### **3.10 VISUAL RESOURCES COMMENTS AND RESPONSES**

## Visual Resources

Figure 3.10-1: Long Path Trail Key Map  
 Minisceongo Park  
 Towns of Haverstraw & Ramapo, Rockland County, New York  
 Base Map: NYS DOT Planimetric Map, Thiells Quad  
 Scale: 1" = 500'

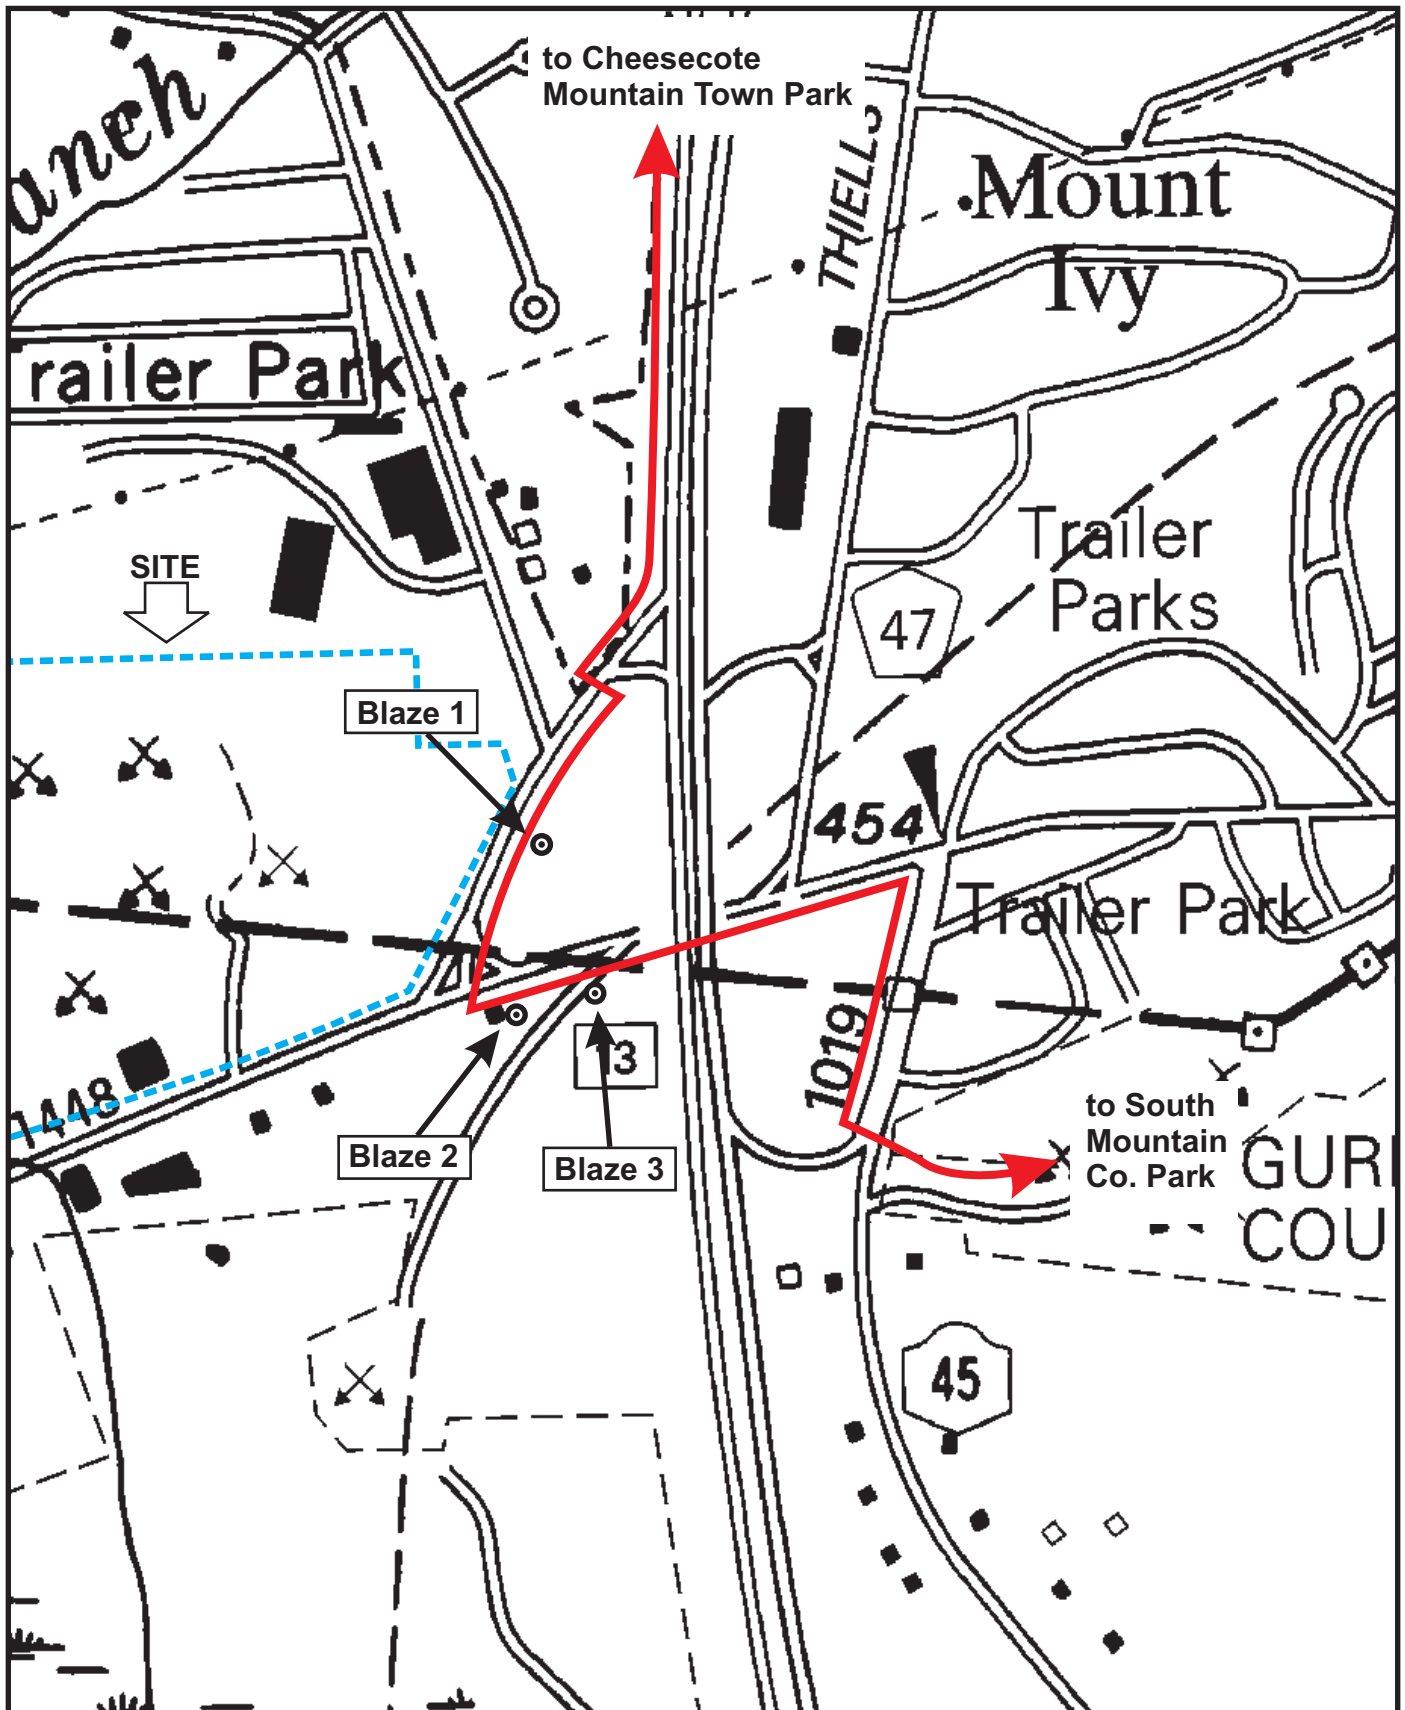
**Comment 3.10-7 (Letter #4 Frederick P. Clark Associates, Inc., March 13, 2009):** The long path should be shown definitively on the map. The text description is not sufficient to judge the impacts to the Long Path views.

**Response 3.10-7:** *Figure 3.10-1 illustrates the location of the Long Path within the project vicinity and Figure 3.10-2 provides photos of the trail blazes within the project vicinity for field verification. The first photo shows a trail blaze that is located on the east side of the Route 202 on/off ramp adjoining the project site to the east. The second blaze is found on a utility pole in front of the Mt. Ivy Diner. Lastly, the third photo illustrates a blaze on the south side of Route 202 approaching its intersection with Route 45. This should assist in providing the commentator with the specific location of the trail in the project vicinity.*

*Potential impacts to the Long Path were examined in the 2006 DEIS, a document that has been incorporated by reference into the SEIS. The text of the DEIS states as follows: "Adjoining the easterly boundary of the Minisceongo Park property is a segment of a regional trail known as the Long Path, maintained by the New York - New Jersey Trail Conference. The path extends from the George Washington Bridge in Fort Lee, New Jersey, to Altamont, NY, in the Albany region. Its route is marked by the "parakeet aqua" blazes on telephone poles and trees. Within the project vicinity, the Long Path follows the right-of-way of the Palisades Interstate Parkway, crossing over the southbound exit ramp at Exit 13. It then follows the off-ramp along the easterly side of the ramp's right-of-way. The Long Path follows the ramp alignment, and crosses over Route 202 in front of the Mt Ivy Diner. It then travels along the south side of Route 202 in an easterly direction, along the park and ride facility, and then heads south along Route 45 to the entrance of Gurnee Park. The site is visible from the Long Path."*

*Views from the Long Path are comparable to views visible from the southbound access ramp. The path is approximately 100 feet from the easterly property line on the easterly side of the ramp. The Long Path connects various parks and open spaces throughout the region and passes through existing suburban and urban areas along its length. In terms of overall context, the Long Path is traveling through a suburbanized area in the project vicinity, passing behind single-family homes, and paralleling highways, including the commercialized portions of Route 202 and Route 45, to connect to Gurnee Park southeast of the project site. Views from this trail are of modern commercial, industrial, and residential uses in this area. The Minisceongo Park project would not be significantly different or in stark contrast to existing suburbanized landscape views visible from the path. With construction of the proposed project, the landscape views*

would continue to be that of a suburbanized landscape. A vegetative buffer will remain between the Long Path and the easterly boundary of the project site, within the PIP ramp rights-of-way. Thus, views of the future commercial space and parking lots would be partially screened during off-leaf time periods and screened during on-leaf conditions. During site plan review, the Ramapo Planning Board and Haverstraw Planning Board will review the landscaping details for the project, and supplemental landscaping will be added at the Boards' direction to further screen views from the Long Path.
